Kenavon Drive, Reading

Proposed Amendments

West Block and Middle Block Stage 4 Amendments, September 2021

West Block Proposed Amendments Drawing Comparison

Ground Floor Plan

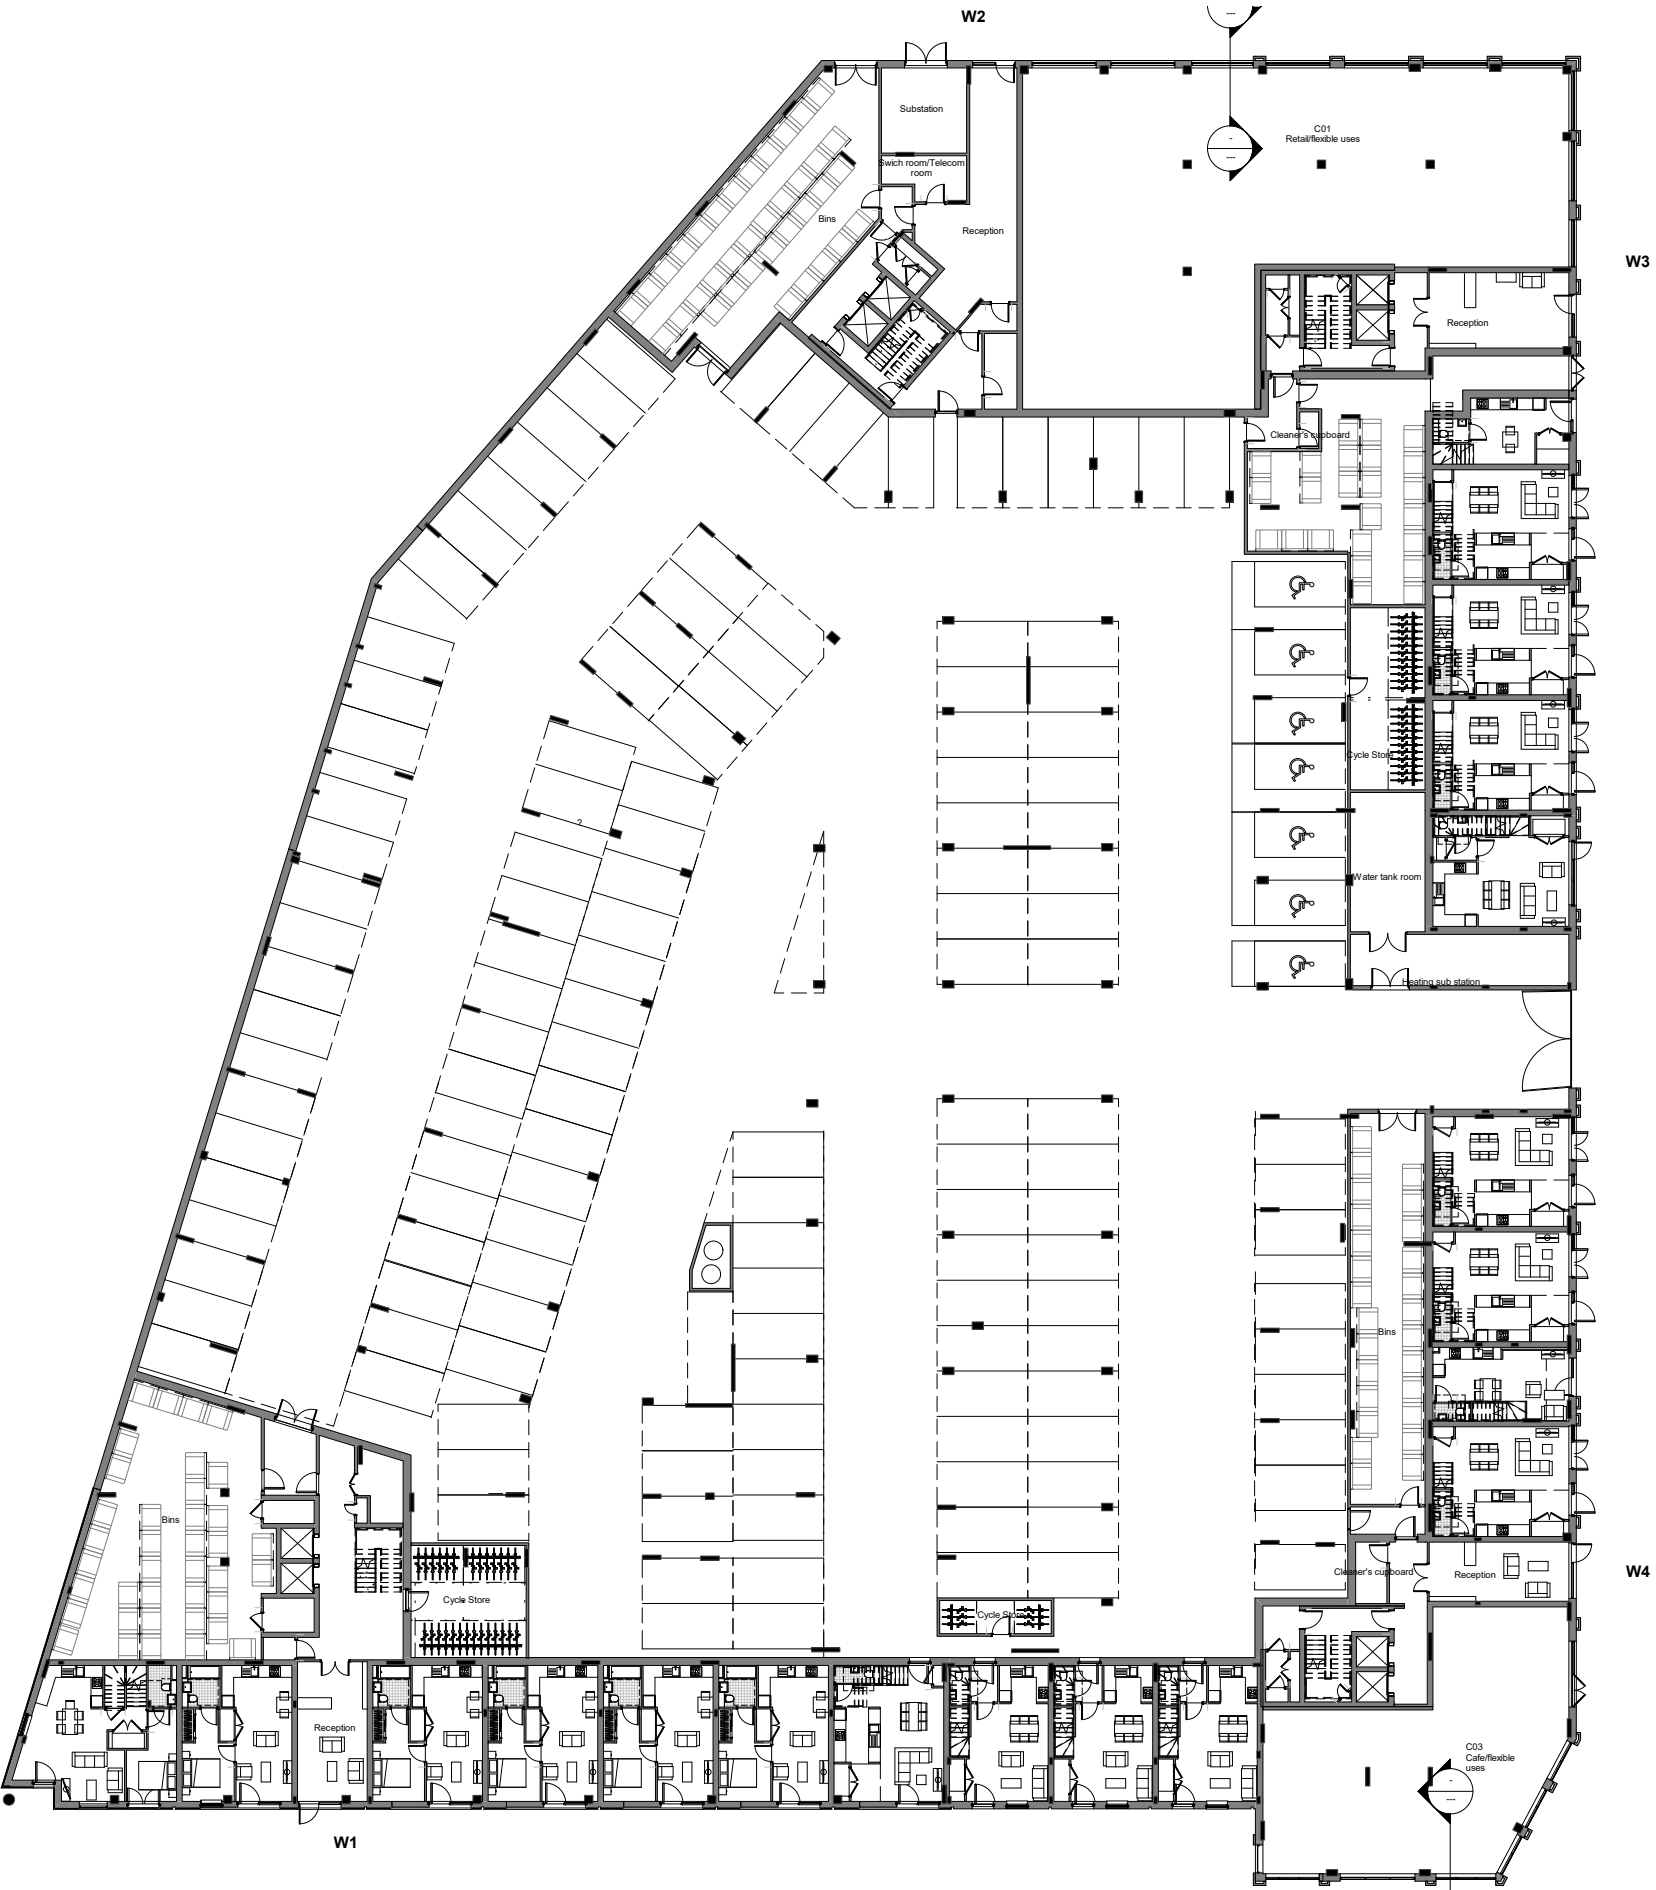
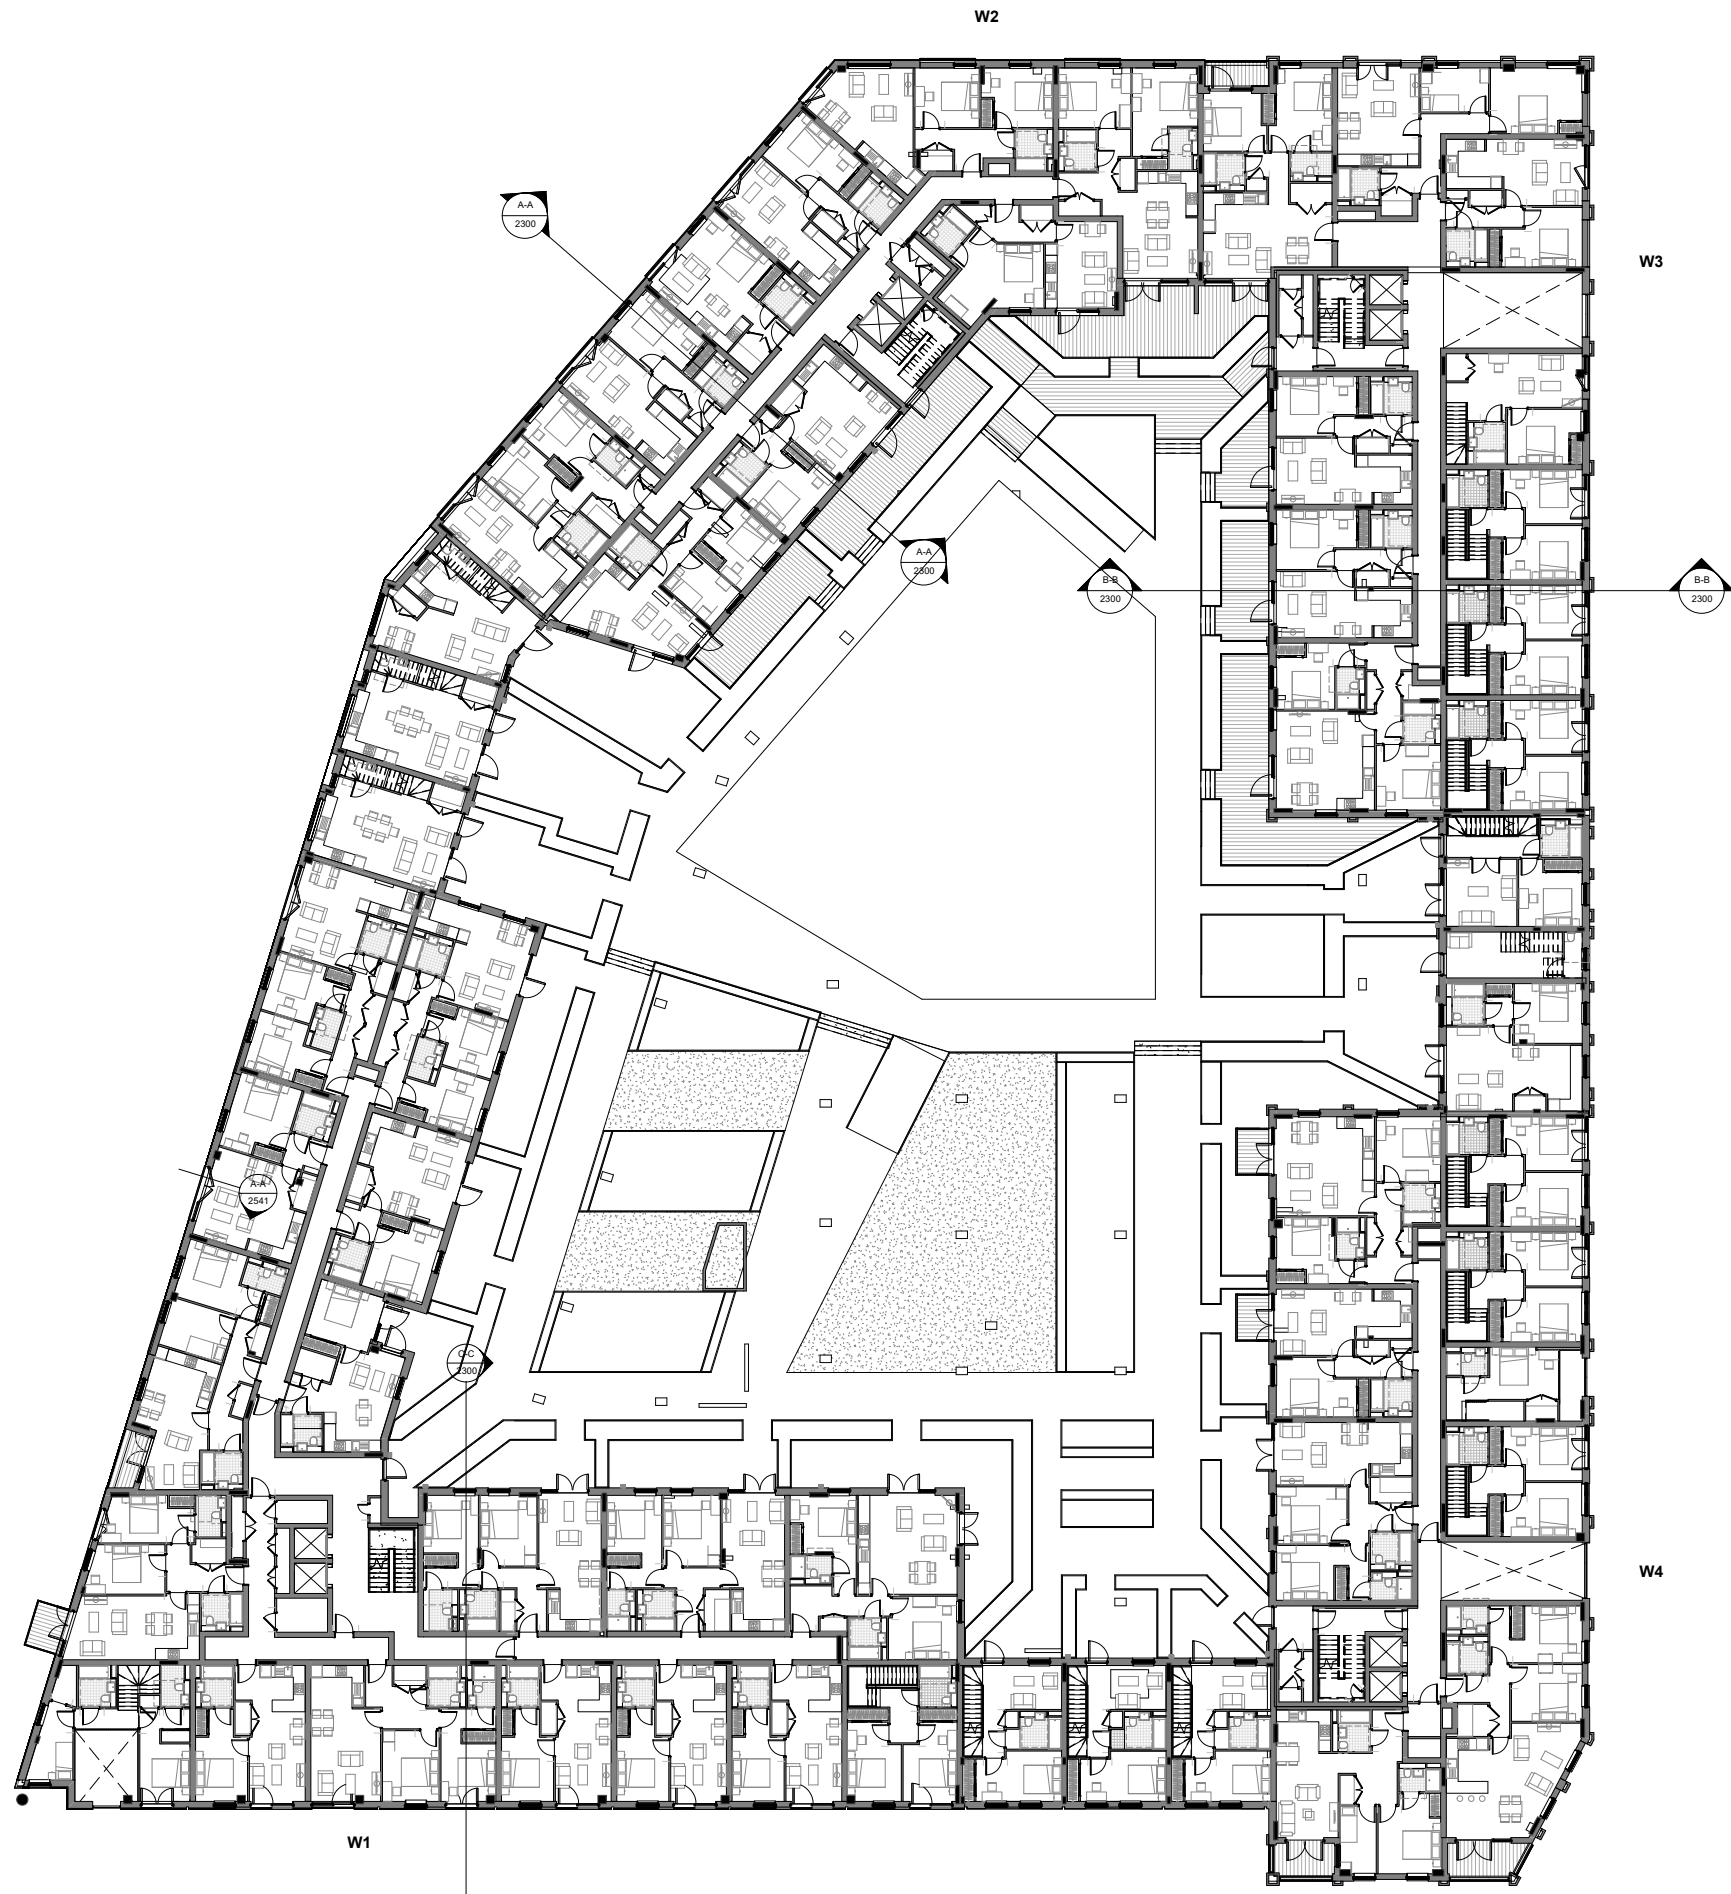
Substation, Plant Rooms, Reception, Bin Store and Bike Store rearranged to allow better access to Substation, Bin Store and Reception to Core W2.

High-level ventilation louvres added to the West Elevation to support the "mixed ventilation" system using a combination of exterior openings, a mechanical extract system and impulse fans.

Undercroft plant rooms and ancillary areas rearranged to fit water tank and ventilation room. Parking layouts updated to suit.

- W1 – No reduction
- W2 – Reduction of 5 no. bins due to geometry change
- W3 – Reduction of 5 no. bins due to geometry change
- W4 – Increase of 2 no. bins to geometry change

Following a managed collection approach, 10 no. 1100L bins would be allocated into the bin holding area by the car park entrance.

Any fully filled bins in Cores W2 and W3 will be swapped with the allocated empty bins in the holding area. This will be carried out by managed collection.

West Block – Increase of 87 cycle spaces

Pedestrian Gate to undercroft added to allow pedestrian access to undercroft without opening vehicular gate.
